## Product / Process Change Notification (PCN)

**PCN #:** PCN\_FePF\_20190315  
**Affected Series:** WE-PF-1280; 7427929xxx  
**PCN Date:** March 06, 2019  
**Effective Date:** March 15, 2019

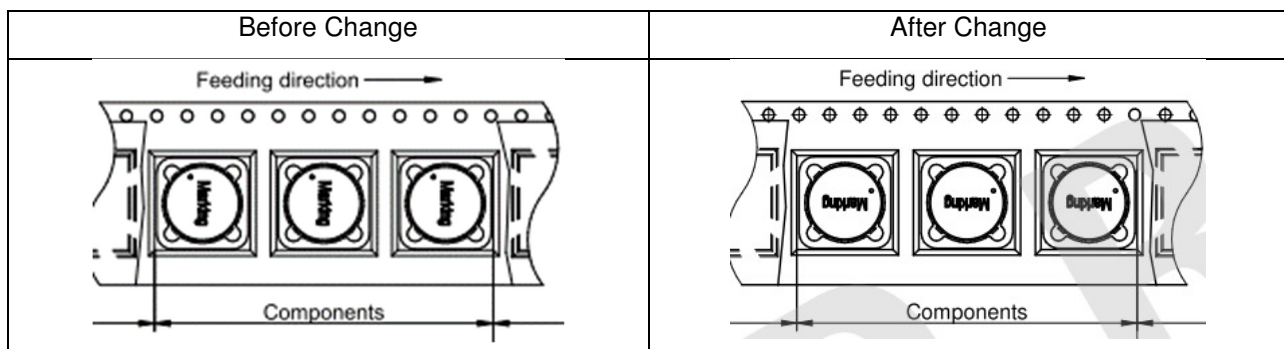
Because of a database mismatch, Würth Elektronik updates the orientation of the component in the carrier tape.

The orientation of the component in the carrier tape is different to the drawing in the datasheet. Because of this the datasheet will be updated to have the same orientation like the parts have it in the carrier tape.

The packing drawing in the datasheet will be updated like following:
